31 January 2017

RE: SSD-5144 MOD 4 Response to Submissions Letter Report

Attachment 1 – Summary and Response to Submissions

Figure 1: Predicted and Licenced Underground Water Extraction

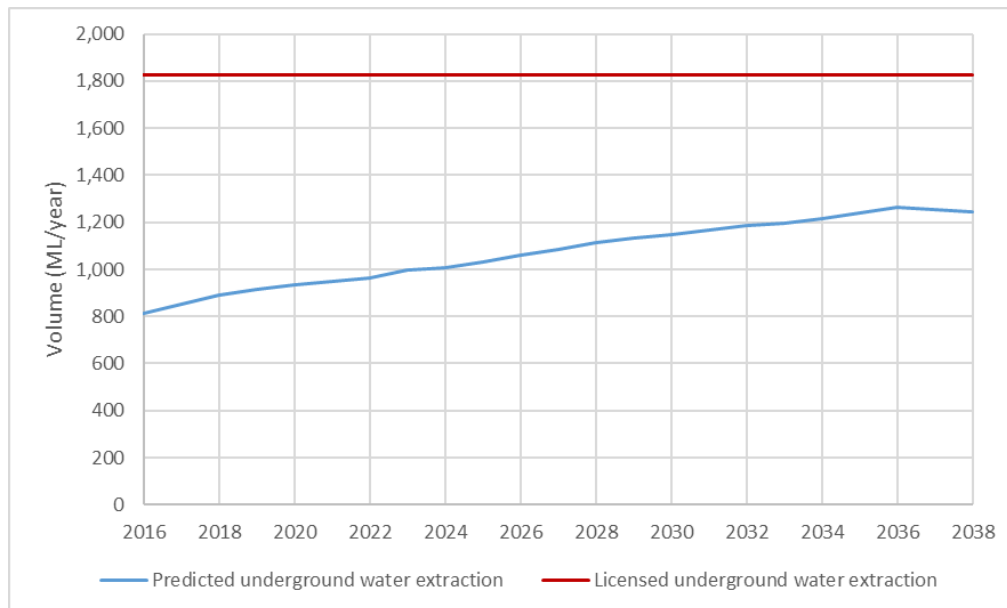
Submission matter: The proponent should provide a consolidated list of all licences held by Centennial Coal in relation to Mandalong Mine under both the Water Management Act 2000 and the Water Act 1912. This should include detail regarding current take from these licences and the excess water entitlement held proposed to account for the incremental increase of take from the proposed modification.

Hydrogeological modelling was undertaken to estimate groundwater seepage into the Mandalong Mine workings and predict groundwater drawdown associated with the mine and the modification. The predicted groundwater inflows into the underground workings were incorporated into the site water and salt balance model. This GoldSim model was used to predict the volume of underground water extracted via the Cooranbong bore, which is presented in **Figure 1** along with the total underground water extraction licensed under WAL 39767 of 1,825 ML/year.

As shown in **Figure 1**, extractions from the Cooranbong Underground Storage area into the Borehole Dam at Cooranbong Entry Site are predicted to peak at 1,263 ML/year in 2036. This volume is less than the licensed extraction volume under WAL 39767 of 1,825 ML/year. As such, no changes to WAL 39767 are proposed as part of the Project.

Plate 3: Cooranbong Colliery Environmental Impact Statement Figure 2.4 Proposed Mining Areas

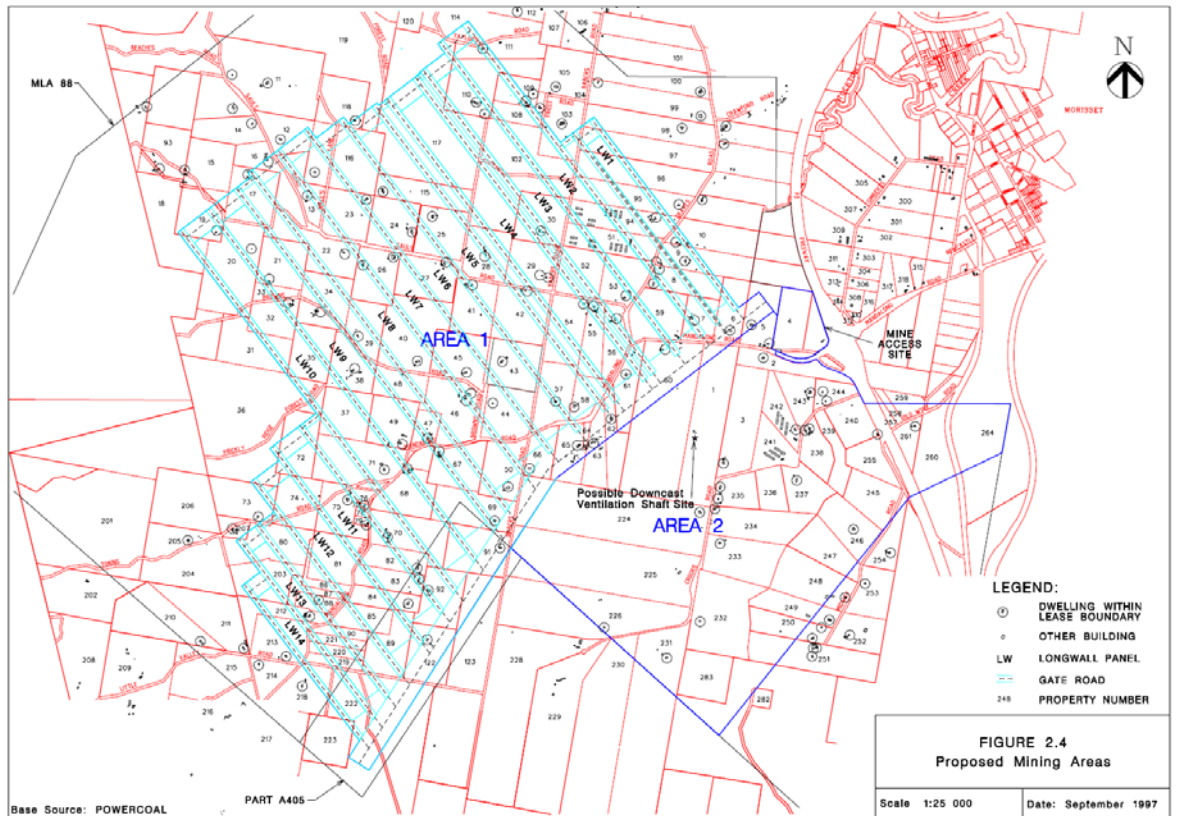
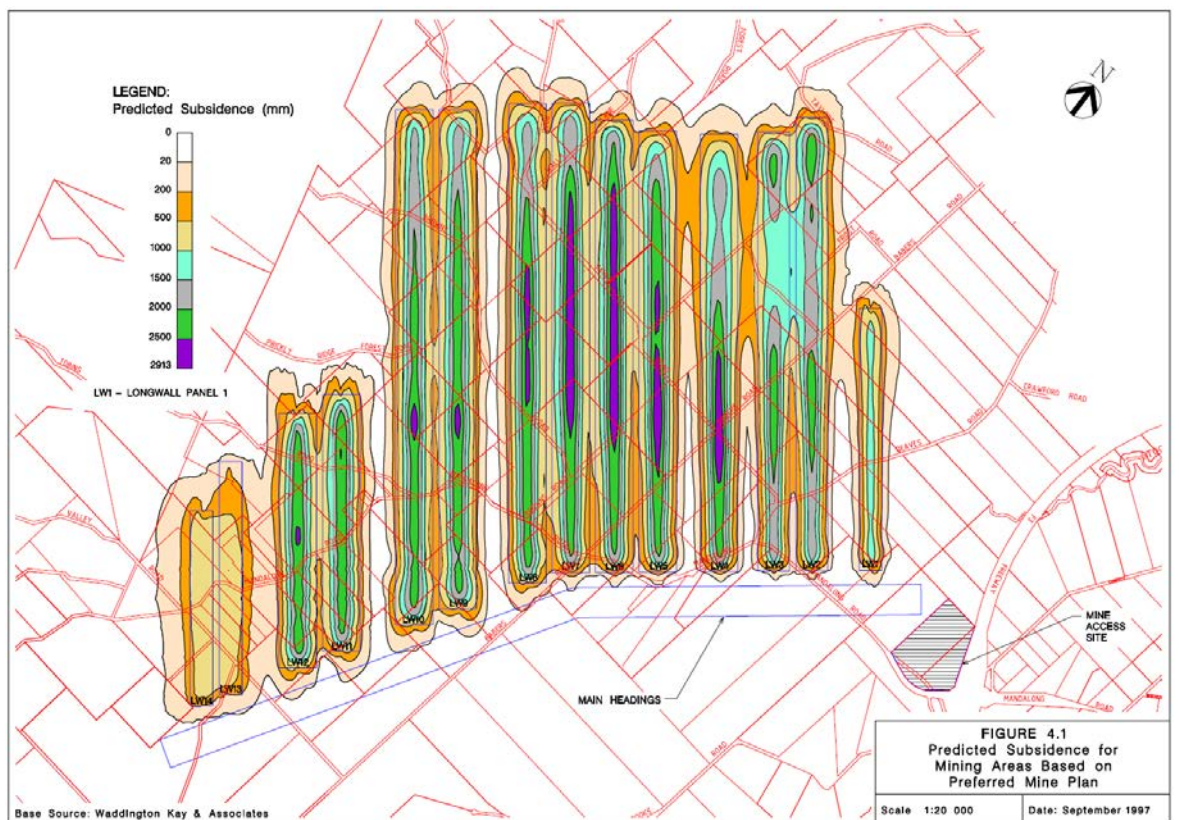
Please clarify the difference between the existing and proposed subsidence predictions at the four locations specified in Table 3 of the Subsidence Predictions Report.

Umwelt (1997) indicates that Building C (cabin) on Property Reference 80 was not constructed at the time the EIS was prepared. As detailed in the LW22-23 Extraction Plan, no Mine Subsidence Board transactions are on file.

Subsidence Predictions from Umwelt (1997) indicate that Building D (dwelling) on Property Reference 207 was located beyond the 20mm limit of subsidence of the proposed mining area (**Plate 3** and **Plate 4**).
